**R44 SERVICE LETTER SL-76A**  
(supersedes R44 SL-76)

**SUBJECT:** C017-4 Swashplate Assembly Spare Parts, and  
C017-6 revision "AA", "AB", & "AC" Swashplate Assembly Spare Parts

**BACKGROUND:** Ongoing product improvements have made some swashplate parts unavailable. Retrofitting earlier swashplates with newer parts is approved as described below. Revision A of this letter describes additional, conforming configuration.

FIGURE 1

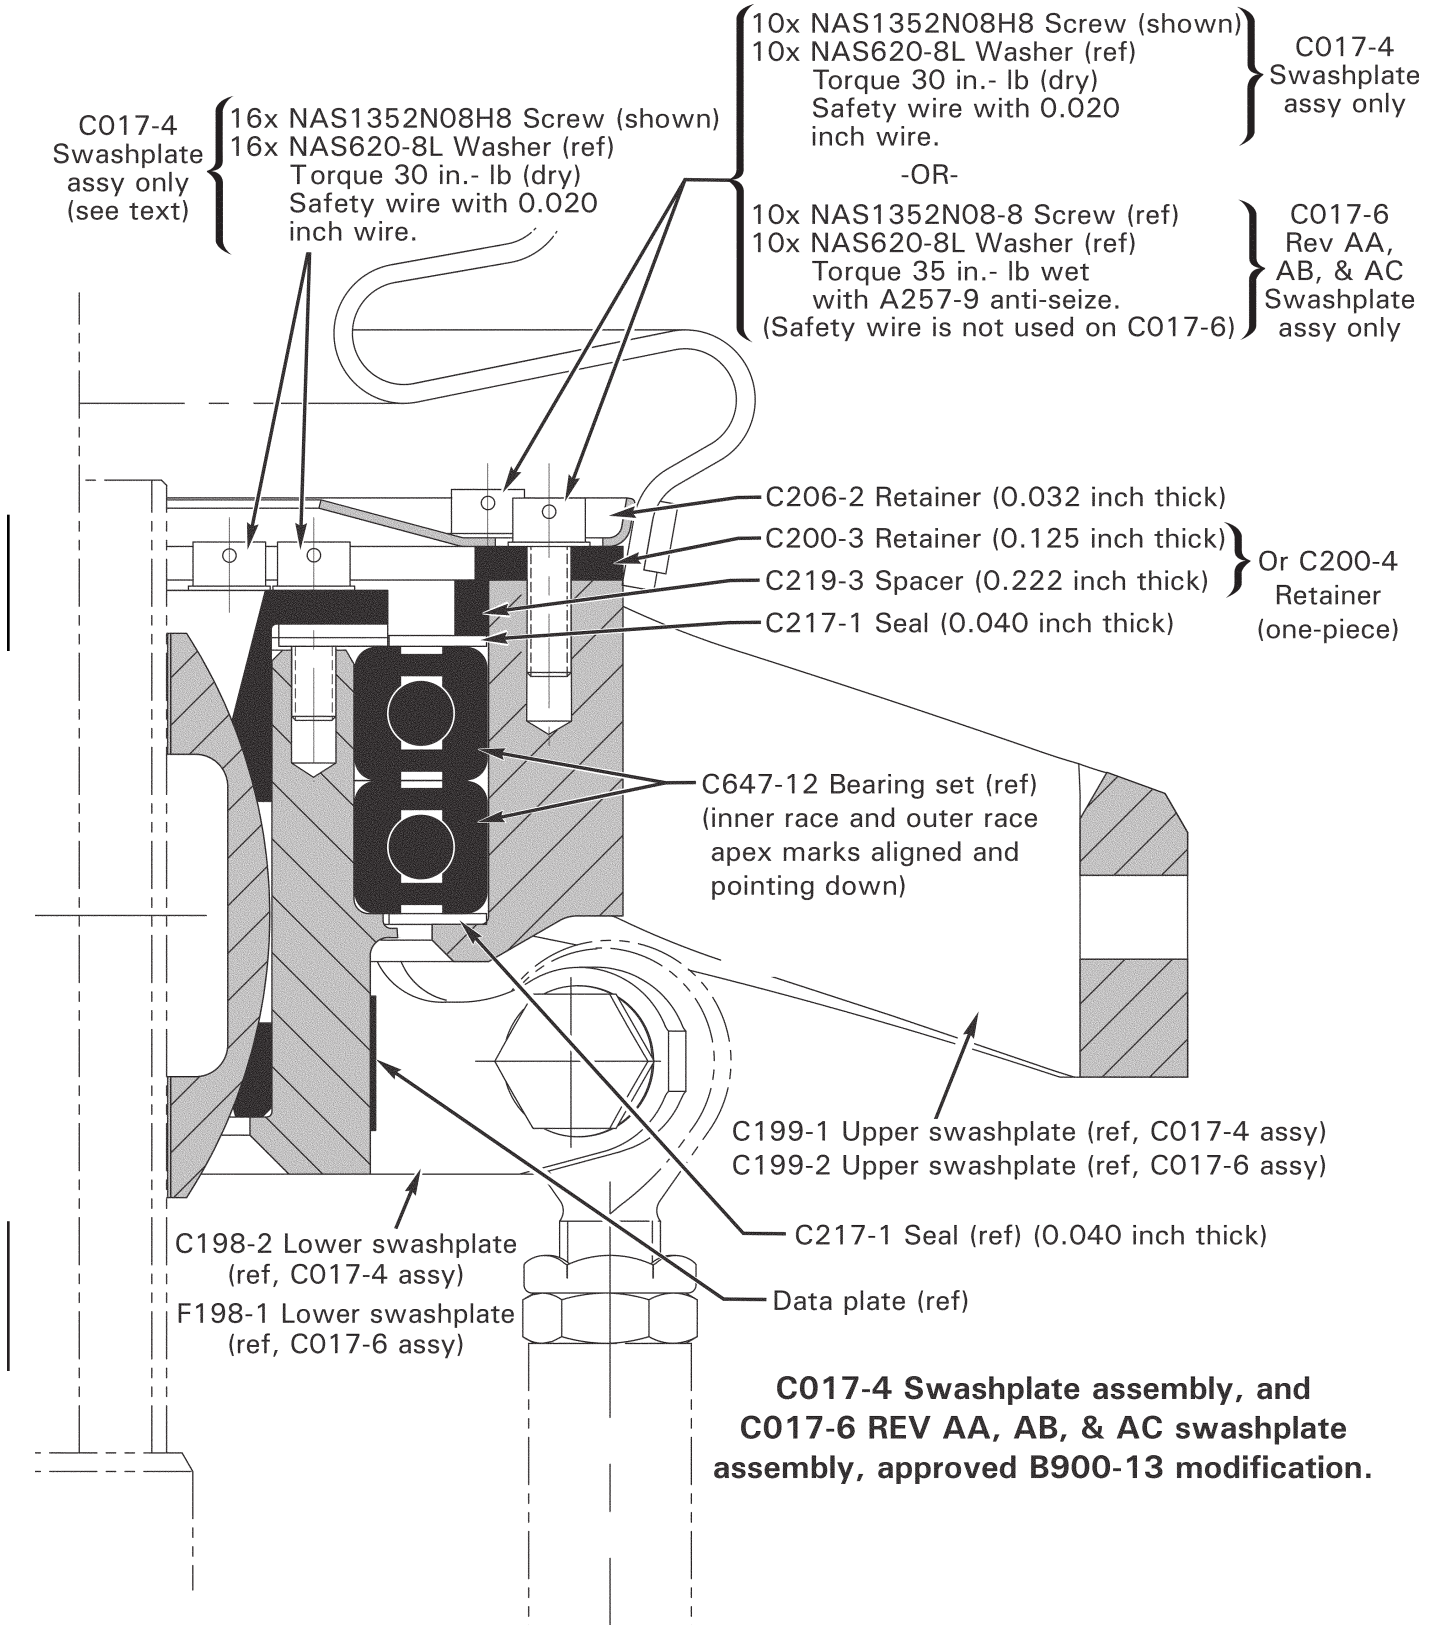
1. If swashplate's data plate indicates part number C017-4, or if part number is C017-6 with revision ("REV") letters "AA", "AB", or "AC", refer to R44 Illustrated Parts Catalog (IPC), Figure 67-75 dated JAN 2014 or later. If any of the following spares are required and cannot be sourced, then remove all of the following parts from swashplate and discard:

- C200-1 retainer,
  - C206-1 retainer,
  - C218-1 shield,
  - C218-2 shield,
  - C219-1 spacer,
  - C219-2 spacer,
  - ten AN503-8-8 slotted-head screws in C199-1 upper swashplate (C017-4 swashplate assy only)

2. Install all of the following replacement parts per Figure 1:
  - C200-4 retainer (supersedes C200-3 retainer & C219-3 spacer),
  - C206-2 retainer,
  - C217-1 seal,

- ten NAS1352N08H8 screws in C199-1 upper swashplate (C017-4 swashplate assy only; to facilitate maintenance, sixteen additional screws may replace AN503 screws in lower swashplate).

3. Using contrasting permanent ink or epoxy paint, mark "B900-13 MOD" on lower swashplate adjacent to C017 data plate. (B900-13 MOD is equivalent to IPC Figure 67-73.)
